City of Alexandria, Virginia

MEMORANDUM

SUBJECT: CONCEPT REVIEW OF 3640 WHEELER AVENUE
(THE MILL BUILDING)
BAR CASE # 2015-0049

PROPOSED CONDITIONS
EZ STORAGE FACILITY
#3640 WHEELER AVENUE
CITY OF ALEXANDRIA, VIRGINIA
SCALE: 1" = 20' DATE: 10 FEBRUARY, 2015

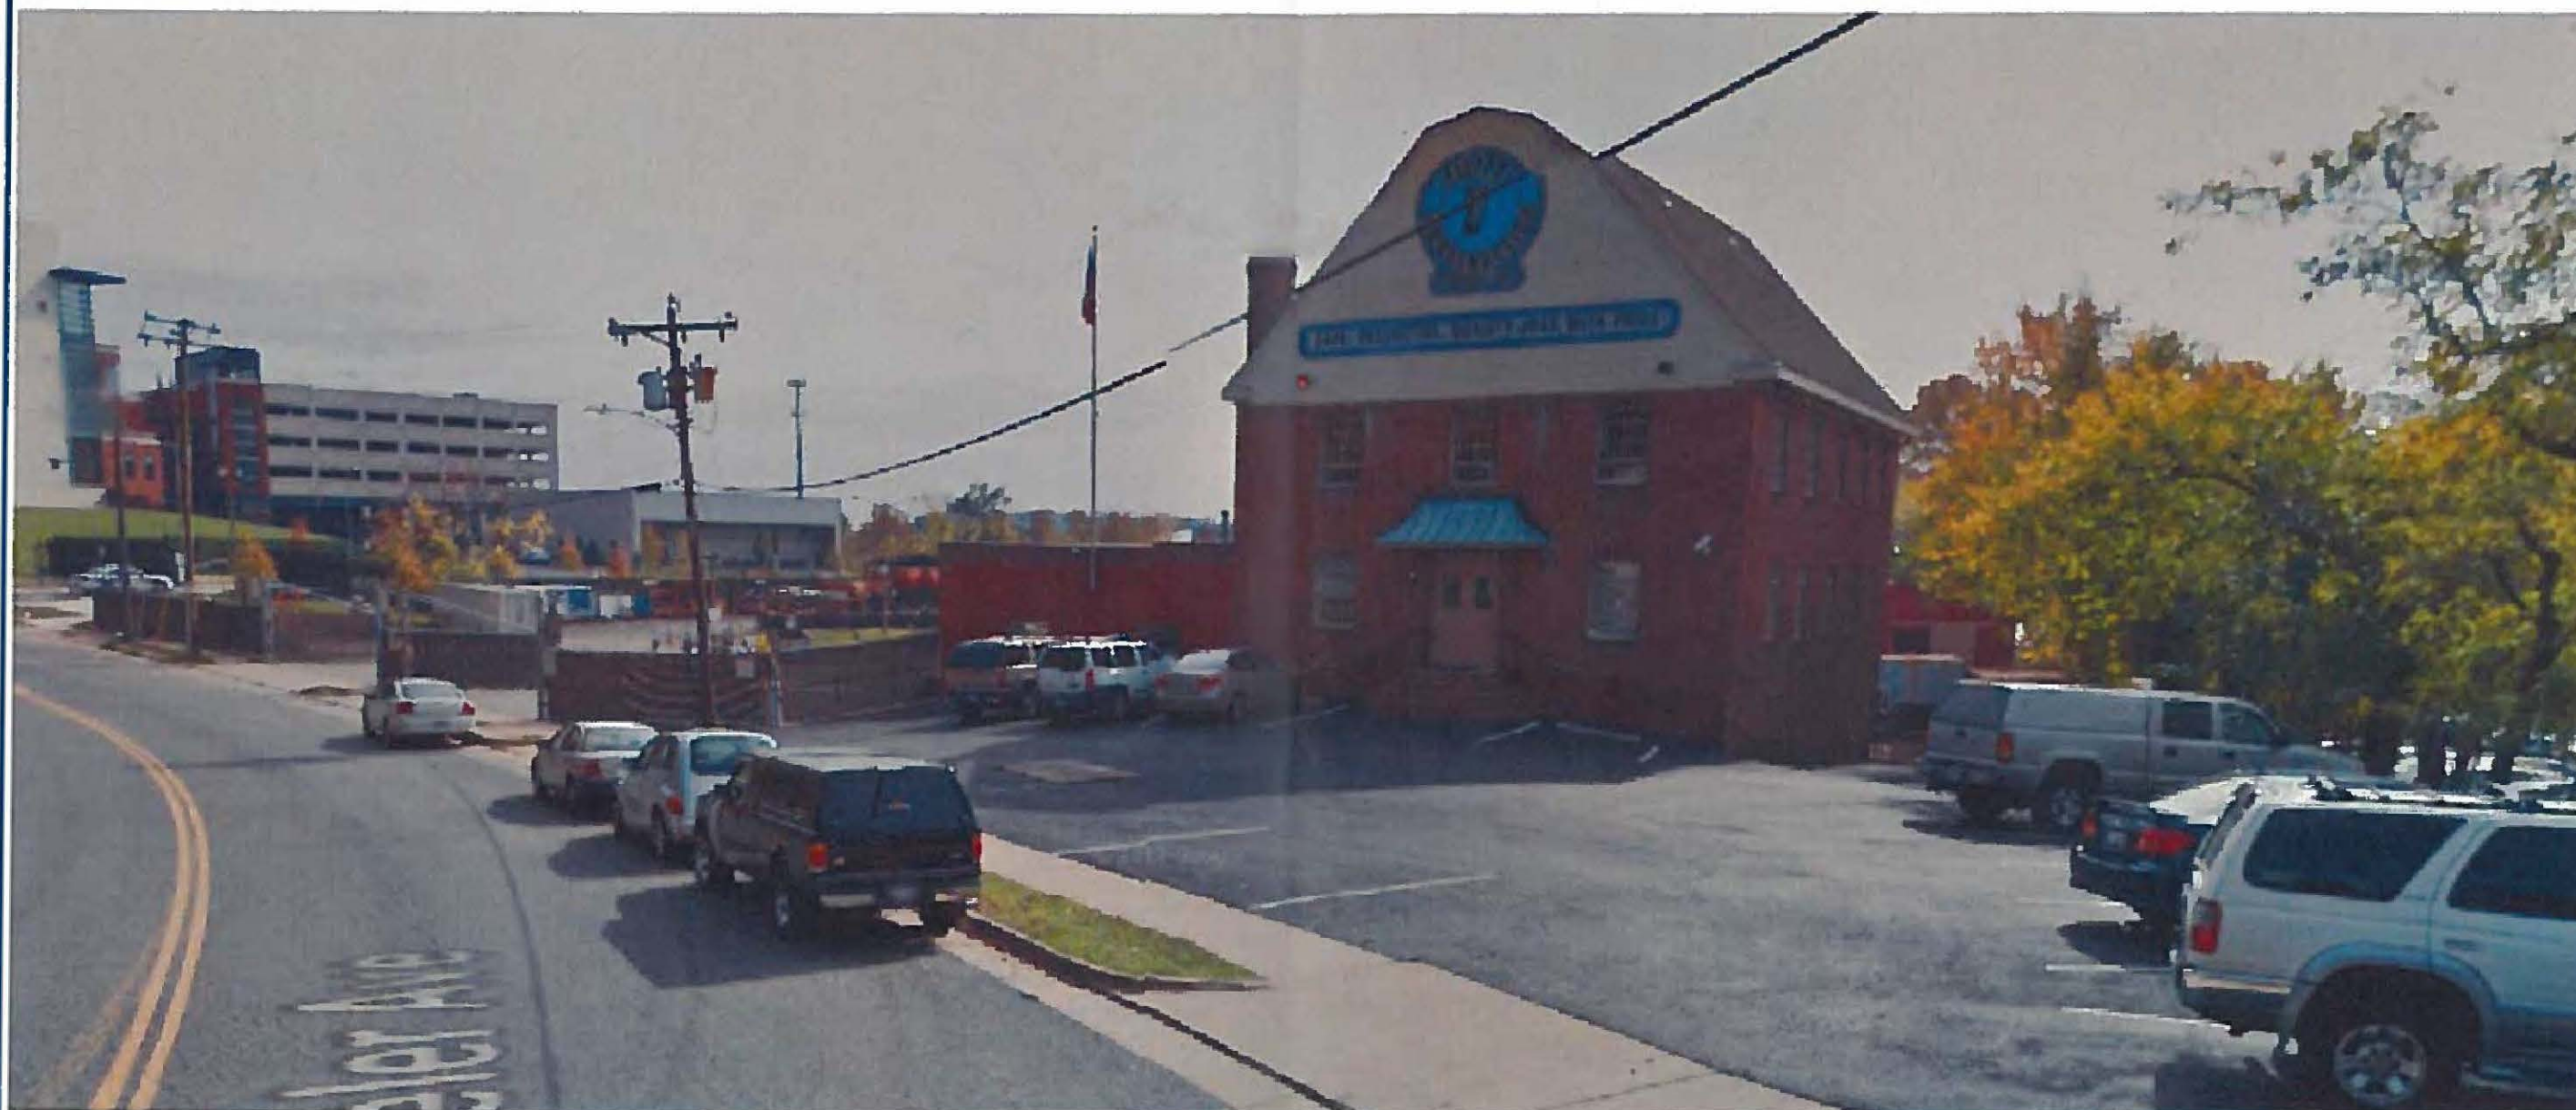
Second, staff finds the handicap ramp to be far too prominent on the historic east elevation and instead recommends a less intrusive solution, such as a mechanical lift, adjacent to the proposed new door. Staff also recommends shifting the surface parking to the south slightly, behind the façade of the new storage building, to increase the landscape area around the historic building and remove cars from the view of the mill building when traveling west on Wheeler Avenue.

- C-4 Construction of the new building will result existing structure becoming accessory. The Accessory building cannot be located forward of the front building wall of the main building.

- F-1 The zone transition setback will apply to the RA zoned property across the street. The applicant is currently proposing 54' to the zone line change, which based on the maximum allowable building height of 50' will comply.

PROPOSED STRUCTURE FRONT ELEVATION

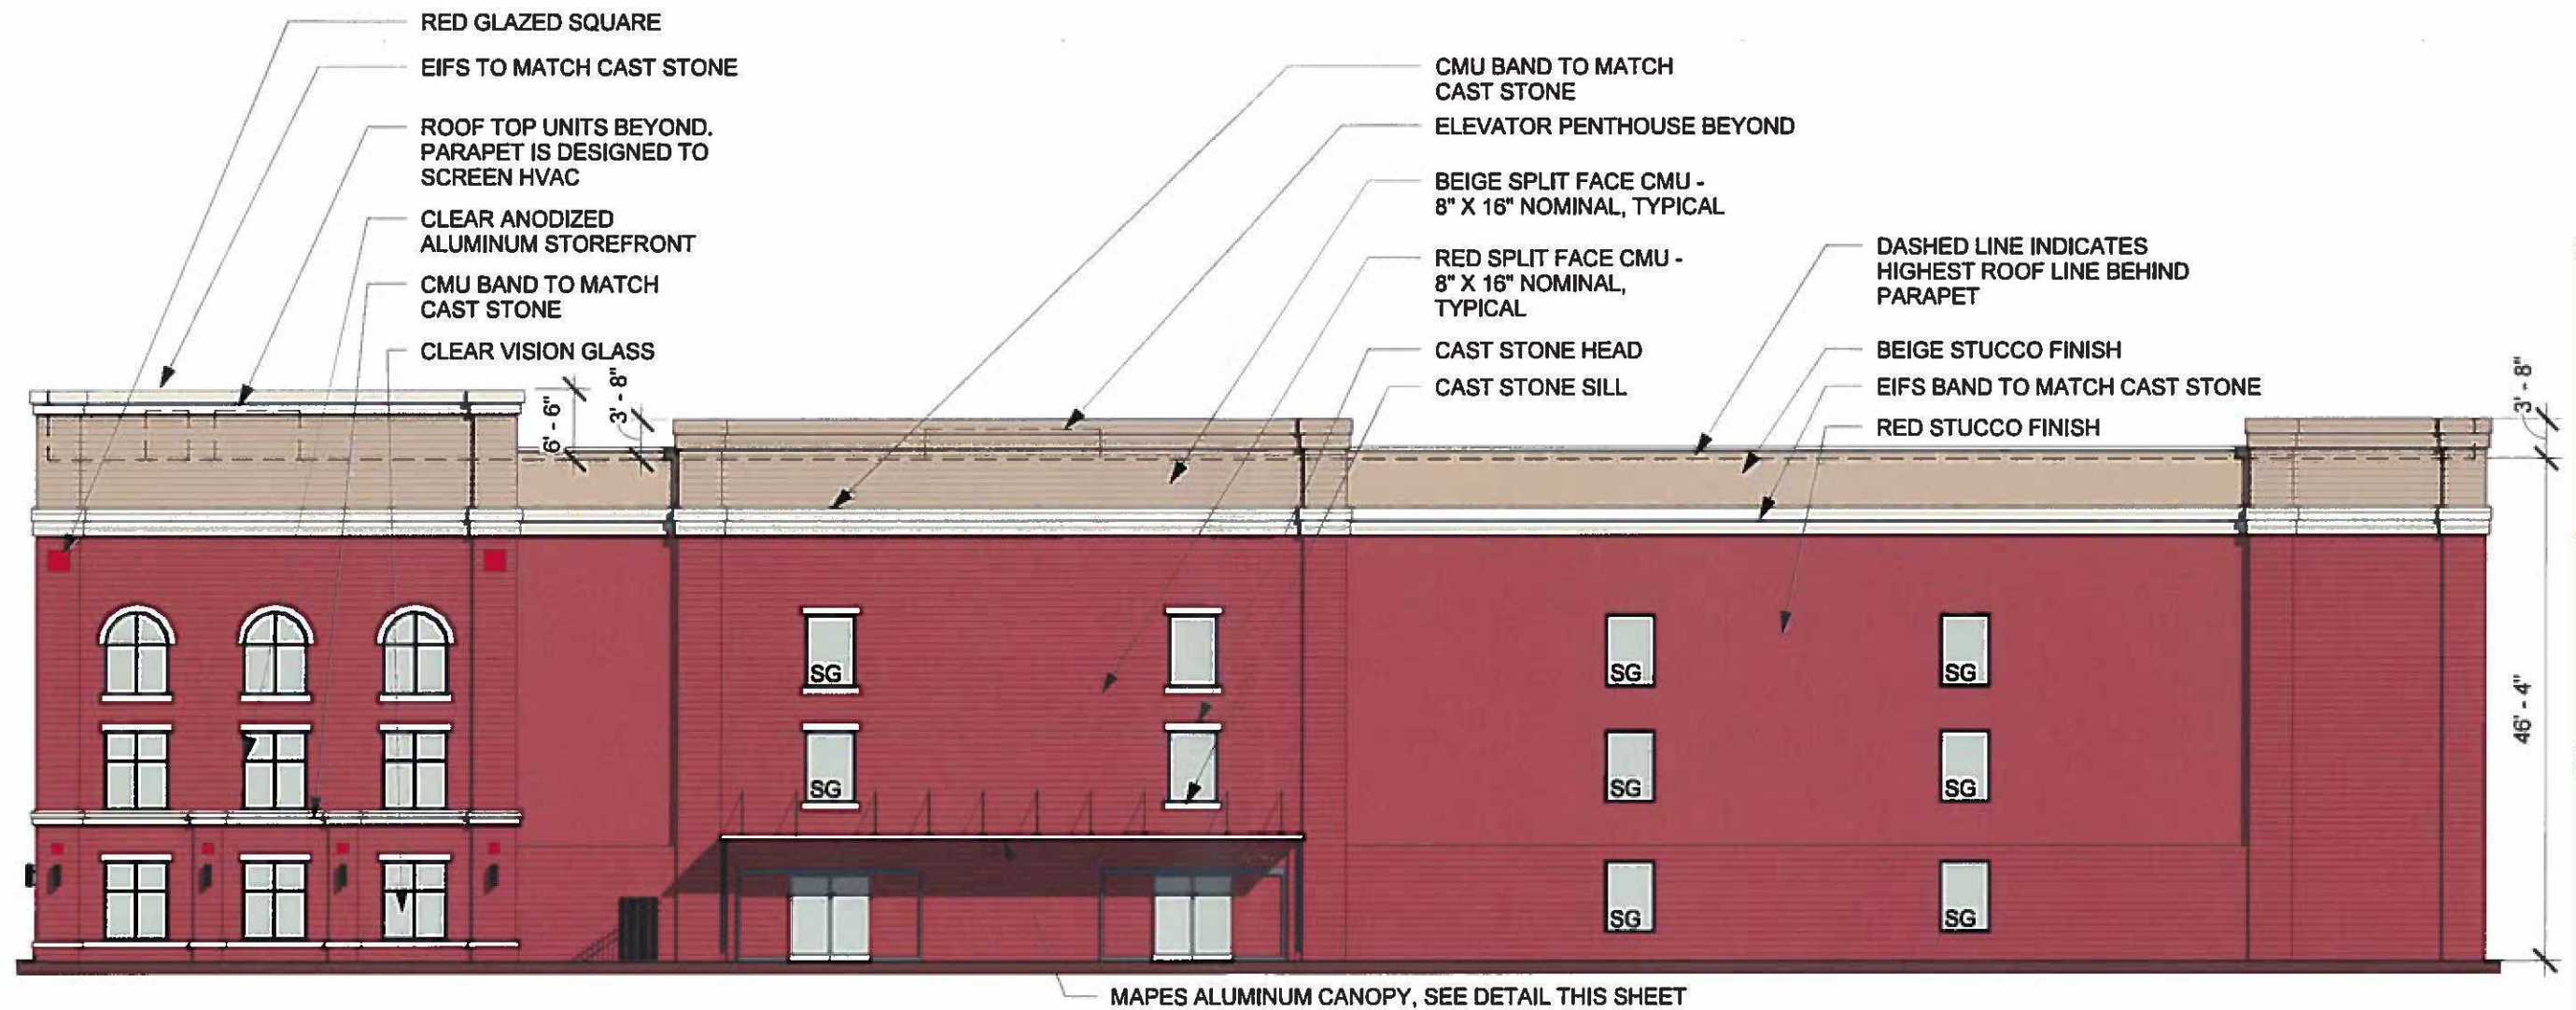
While this is only concept review, staff recommends restudy of some relatively minor features before proceeding with the DSUP process, primarily to the proposed fourth floor of the building and the proposed signage. Although the building will provide four levels of storage, only the first three stories will have any fenestration, creating a disproportionately large frieze band and a parapet that primarily serves as a backdrop for the proposed signage. Staff recommends a more classical facade proportion and the addition of fourth floor windows.

Staff also cannot support the proposed large back-lit box signs. As noted in the zoning comments below, some of the signs are located above the roofline or not facing a public street and are not permitted by the zoning ordinance. Not only are they visually too large but they are back-lit (internally illuminated plastic face letters), which the Board very rarely supports. Staff supports smaller and more subtle signs, with halo or external illumination which can be explored with the applicant as part of the fourth floor restudy, prior to their return to the BAR.

- 2) Section 2-154(D) states that in the case of a flat roof with a parapet wall which is three feet in height or less, the highest point shall be the roof line. Therefore, in instances where the parapet is taller than 3', the building height shall be the top of the parapet wall. All proposed parapet walls exceed 3', resulting in areas of the building where the height measured to the top of the parapet wall exceeds 50' and does not comply with zoning.

- C-3 Staff cannot determine zoning compliance for proposed signs. Applicant must address the following issues related to signs:
- 1) Proposed sign is located above the roofline. Rooftop signs are not permitted.

- 2) Applicant must submit dimensions of all proposed signs and building widths for all elevations where signs are proposed.
 - 3) Identification signs are only permitted to state the name and use of the building/structure. Remove "Climate Controlled" from the proposed signage.
